SERVICE BULLETIN

TR-2400

#808

SUBJECT: TR-2400 OFFSET FAILURE

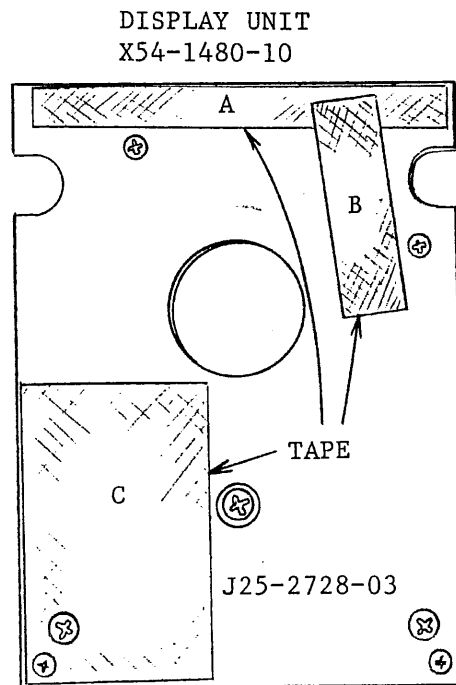
For intermittent or no offset, suspect an intermittent short between the metal body of the REV NOR SW and an adjacent jumper on the PCB, or intermittent contact between the volume control metal body and the PLL PCB.

1. Disassemble the radio and inspect the board to the right of the REV/NOR SW. Using a small flat blade screwdriver or similar tool, gently pry the short metal jumper and the metal body switch tab apart. This should clear the offset trouble. (Fig.1)
